Comments on the Jirau Hydropower Project: Transboundary Impacts
Submitted to Lloyd's Register Quality Assurance Ltd.

May 22, 2012

Figure 1: Water levels in Abuna (m)

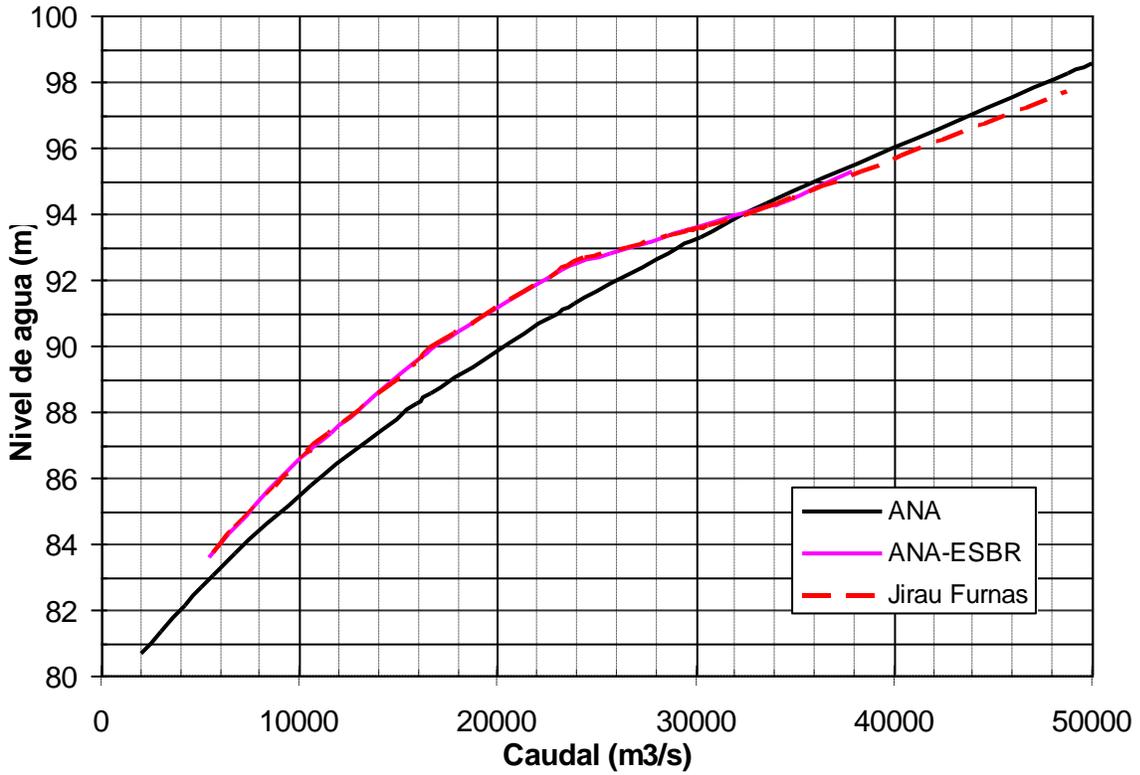
The Jirau HPP will cause transboundary impacts in upstream areas of neighboring Bolivia and Peru. The PDD ignores these impacts. However, feasibility and EIA studies (Furnas, Odebrecht, 2004) already identified cross-border impacts, often without mentioning them explicitly as such. One of the most important impacts is the effect on the water levels along the binational stretch of the Madera River, stretch that extends from the confluence with the Abuna River at its downstream end to the confluence of the Beni and Mamoré rivers upstream. Contrary to what the PDD mentions (page 8), the feasibility study (Chapter 7) shows that even operating the Jirau reservoir with varying levels (table 2 of the PDD), water levels in the Madera River near the city

of Abuna will increase, at least for medium and low flows. The city of Abuna is located on the Brazilian side of the binational stretch. The western shore to the front is Bolivian.

Water levels in the binational stretch would be increased further as a result of the sedimentation induced by the reservoir (Chapter 7 of the EIA, Switkes, 2008). ANEEL and the authors of the EIA subsequently denied their own results, relying on simple "views" (i.e. opinions and not studies) of supposed experts.

The main consequences of the increase of the river water levels in the binational stretch would be the loss of potential energy in that stretch and the increase in the frequency and duration of floods in Bolivian territory. The loss of potential energy can be estimated readily in monetary terms. Even for the modest increase in water levels estimated in the feasibility study and the cost of energy to which was awarded, the value of the energy lost in the binational stretch would be 70 million dollars per year, and over 100 million dollars per year according to independent studies (Molina et al, 2008).

The process of licensing shows serious inconsistencies with Brazilian and international laws. The results of the studies of water levels referred to in point a) of these commentaries are an example. Incredibly, Resolution ANA 555/2006, referred to in the PDD, adopted as the stage-discharge curve in Abuna (curve ANA-ESBR of figure 1 of Annex) the curve (Jirau Furnas in figure 1 of the Annex) which according to the feasibility studies, is the one modified by the operation of the Jirau reservoir. The original natural curve was the ANA curve of figure 1. Furthermore, the ESBR consortium in charge of developing Jirau submitted the technical note ESBR UHE JIRAU/ANEEL 001-2008, which reduces, arbitrarily and without technical support, friction losses in the future reservoir, in order to further reduce modified water levels in the binational stretch. This was observed by the Bolivian delegation, at the binational technical meeting held on 30 and 31 October 2008, while the Brazilian delegation could not give a reply. Moreover, a study (Molina et al, 2008) showed that the use of the original friction coefficients of the feasibility study significantly increase water levels in Abuna in relation to natural levels (Figure 2).
